Access Compliance Report

Public Rights-of-Way

Intersection ID: 47852	Main Street: CACTUS_VALLEY_RD	Cross Street: STONE_PORCH_RD	Location: W
ADA ID: 9283A3603744	Ramp Type: PerpDiag	Initial Pass/Fail: Fail	Overall Compliance: No
		Severity Score: 10

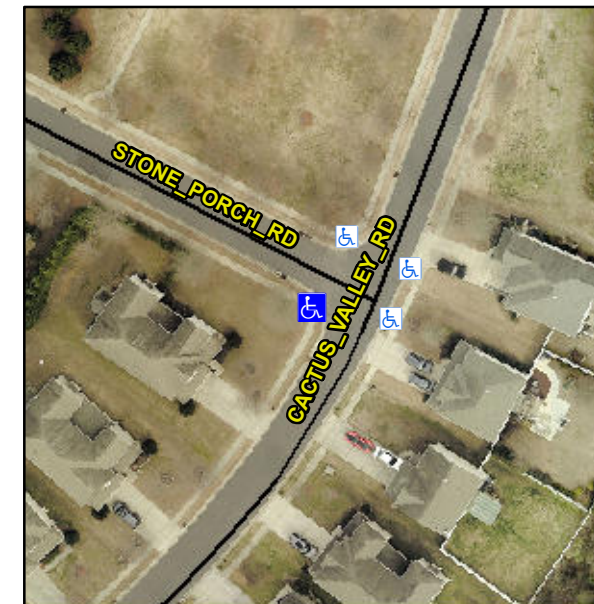
Not Found, R304.5.1, R304.5.3

Compliance	Description	Data	Compliance	Description	Data
N/A	Ramp Length (in)	47.0	Yes	Ramp Slope (%)	7.1
No	Ramp Width (in)	46.0	No	Ramp XSlope (%)	3.9
N/A	Flare Type LT	N/A	N/A	Flare Type RT	N/A
N/A	Flare Slope LT (%)	N/A	N/A	Flare Slope RT (%)	N/A
N/A	Flare Traversable LT?	N/A	N/A	Flare Traversable RT?	N/A
N/A	Landing Length (in)	N/A	N/A	DWS Provided?	N/A
N/A	Landing Width (in)	N/A	N/A	DWS Contrast?	N/A
N/A	Landing Slope (%)	N/A	N/A	DWS Length (in)	N/A
N/A	Landing X Slope (%)	N/A	N/A	DWS Full Width?	N/A
N/A	Landing Curb? (Y/N)	N/A	N/A	DWS Offset (in)	N/A
N/A	Shared Landing?	N/A			
N/A	Gutter Ponding?	N/A	N/A	Gutter Slope (%)	N/A
N/A	Gutter Lip Ht (in)	N/A	N/A	Gutter X Slope (%)	N/A
N/A	Painted X Walk1?	No	N/A	Painted X Walk2?	No
	X Walk 1 Direction	To SE		X Walk 2 Direction	To NE
N/A	X Walk 1 Width (in)	N/A	N/A	X Walk 2 Width (in)	N/A
	X Walk 1 Slope (%)	2.5		X Walk 2 Slope (%)	2.9
	X Walk 1 X Slope (%)	4.2		X Walk 2 X Slope (%)	2.0

Remove & Replace Curb Ramp With Two New Directional Ramps or Equivalent.
